Access Compliance Report

Public Rights-of-Way (Curb Ramps)

Intersection ID: 14946	Main Street: DILWORTH_RD_WEST	Cross Street: E WORTHINGTON AV	Location:	N
ADA ID: A9EAB5F02A8E	Ramp Type: Perp	Initial Pass/Fail: Fail	Overall Compliance: No	Severity Score: 1.25

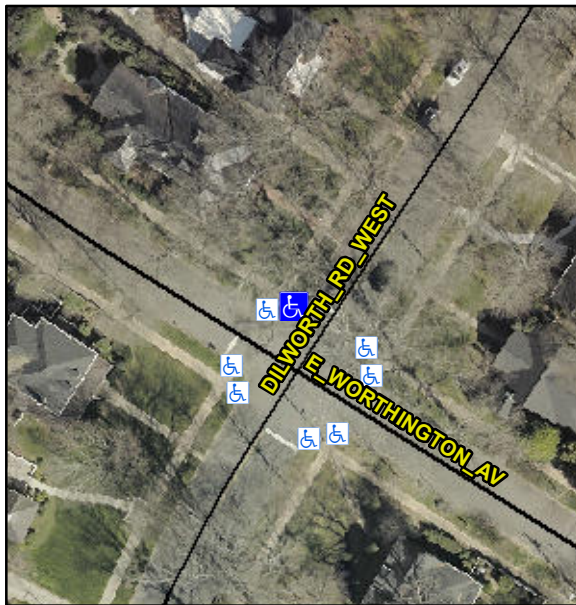
Not Found, R304.5.3

Compliance	Description	Data	Compliance	Description	Data
N/A	Ramp Length (in)	32.0	Yes	Ramp Slope (%)	5.5
Yes	Ramp Width (in)	48.0	No	Ramp XSlope (%)	3.4
N/A	Flare Type LT	N/A	N/A	Flare Type RT	N/A
N/A	Flare Slope LT (%)	N/A	N/A	Flare Slope RT (%)	N/A
N/A	Flare Traversable LT?	N/A	N/A	Flare Traversable RT?	N/A
N/A	Landing Length (in)	N/A	N/A	DWS Provided?	N/A
N/A	Landing Width (in)	N/A	N/A	DWS Contrast?	N/A
N/A	Landing Slope (%)	N/A	N/A	DWS Length (in)	N/A
N/A	Landing X Slope (%)	N/A	N/A	DWS Full Width?	N/A
N/A	Landing Curb? (Y/N)	N/A	N/A	DWS Offset (in)	N/A
N/A	Shared Landing?	N/A			
N/A	Gutter Ponding?	N/A	N/A	Gutter Slope (%)	N/A
N/A	Gutter Lip Ht (in)	N/A	N/A	Gutter X Slope (%)	N/A
N/A	Painted X Walk1?	No	N/A	Painted X Walk2?	N/A
	X Walk 1 Direction	To SE		X Walk 2 Direction	N/A
N/A	X Walk 1 Width (in)	N/A	N/A	X Walk 2 Width (in)	N/A
	X Walk 1 Slope (%)	4.2		X Walk 2 Slope (%)	N/A
	X Walk 1 X Slope (%)	1.8		X Walk 2 X Slope (%)	N/A

Remove & Replace Entire Ramp.
